KMR.CDD.OIQ.1913-1914.04

ORDERS UNDER SECTION 96 (2) OF ACT III OF 1910.

*Plan showing the house to be built
on plot No. 238-A, 2 Old Town Qtr.
Scale 8 feet to 1 inch.*

With reference to his application dated 7th instant, with a plan for building a house on plot No. 238, A-2 Old Town quarter, Mr. Gangaram Amalmal per Assa Gangaram is informed that the two store room of each floor shown on the plan are not required and the same must be formed in ^{bigger} higher room and a bigger ventilation or other means ventilation and light must be provided as the present shown ~~is~~ inadequate.

1ST & 2ND FLOOR

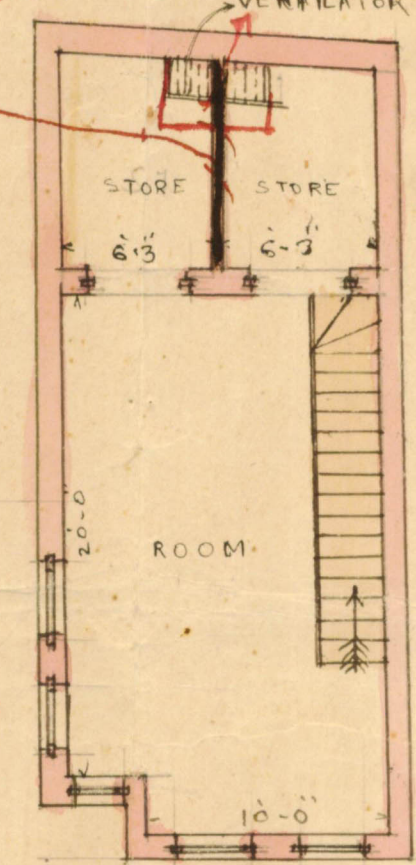
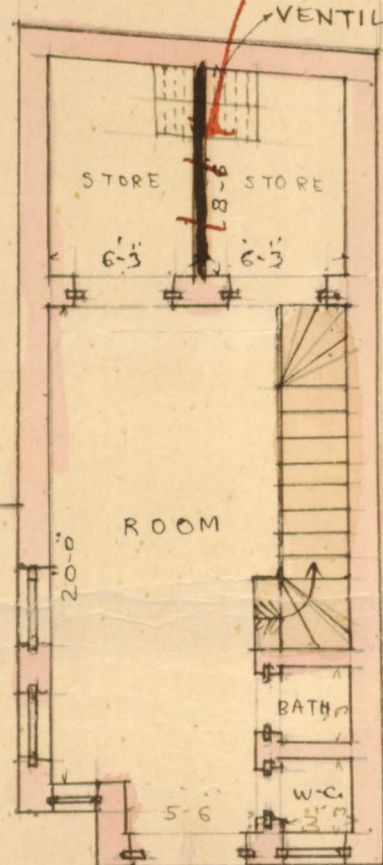
marks— It seems no necessity that the applicant should have 2 store rooms on each floor, which means the rooms are small, dark giving access to rats & vermin, hence highly insalubrious.

2nd instant I beg to inform you that I
have deleted the partition and wish
to have only one room as per plan I
hope you will be good enough to grant
me pass at an early date.

With reference to
this I beg to report that
the applicant has removed
the partition wall and
now has a room, but
there is no objection
to grant the pass.
The street practically
on two sides -
